February 16, 2021

Christian Klein, Chair
Zoning Board of Appeals
Town of Arlington
Arlington, MA 02476

RE: Arlington Land Trust – Weston & Sampson Resiliency Review

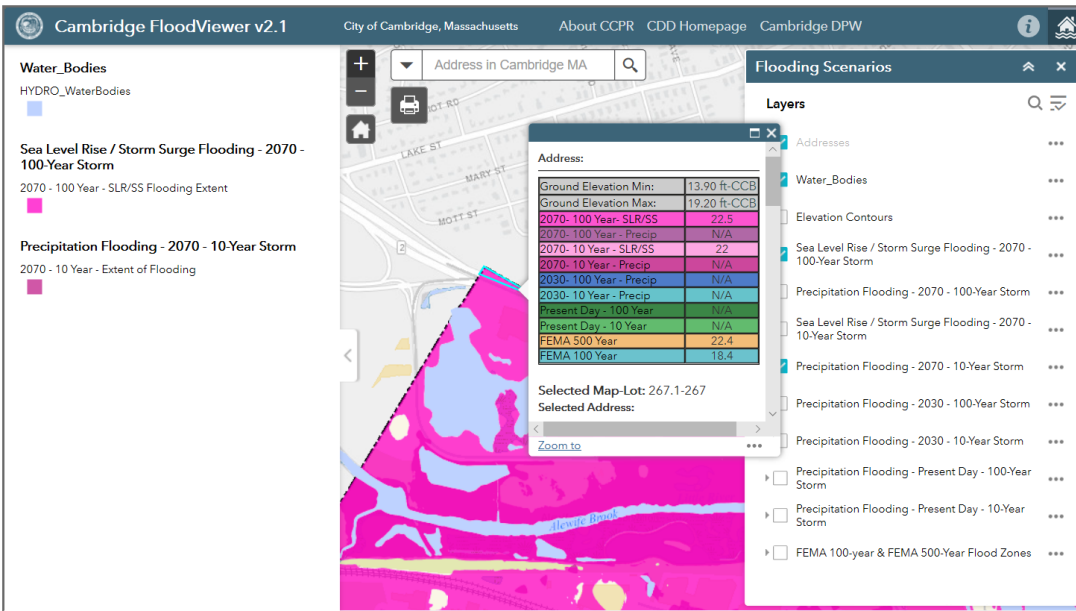
- Figures 1 through 7 of the Weston & Sampson memorandum depict scenes after previous storm events. It is important to note that the figures primarily depict locations east of the Minuteman Bikeway, adjacent to Alewife Brook, located within the FEMA Floodway and at elevations approximately 3 – 5 feet lower than the area of the Site proposed for development. These Figures are not representative of the area of the Site proposed for development.
